GOVERNMENT OF INDIA
MINISTRY OF ENVIRONMENT & FORESTS
Central Zoo Authority

Sub:- Construction of enclosures at Nagaland Zoological Park, Rangapahar.

The designs for the construction of enclosures for Great Indian hornbill, Barking deer, Hoolock gibbon, Fox, Common leopard, Stump tailed macaque, Burmese tortoise, Jungle cat and 2.5 km metalled by pass road at Nagaland Zoological Park, Rangapahar were placed before the Meeting of the Expert Group on Zoo Designing of the Central Zoo Authority held on 12th December, 2011. The observations of the committee are given below:-

COMMON LEOPARD ENCLOSURE.

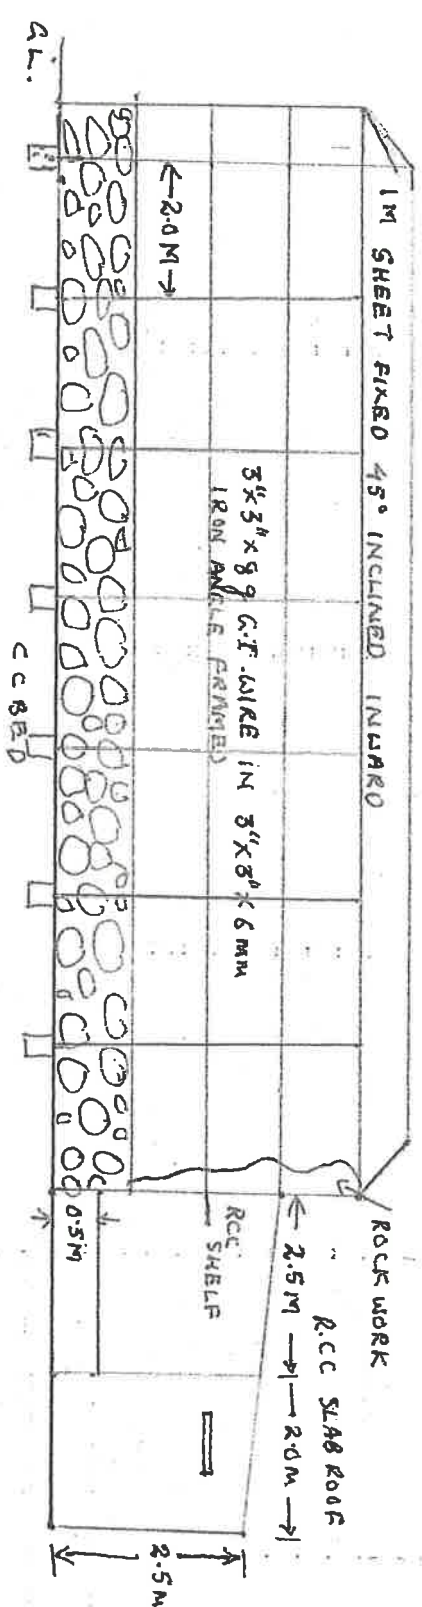
- (a) The width of the inclined sheet use as a barrier should not be less than 2.5 meter.
- (b) The D-4 should be located side wise and D-5 should be used as a lifting door.
- (c) The squeeze cage should be located inside attached with a cell and should be of small in size.
- (d) The kraal should be kept outside of the feeding and retiring cells and the kraal location should be interchanged with squeeze cage.

Keeping in view of the above, revised design should be submitted to the Central Zoo Authority for records. A copy of the design indicating the necessary amendments to made are enclosed herewith for your perusal.
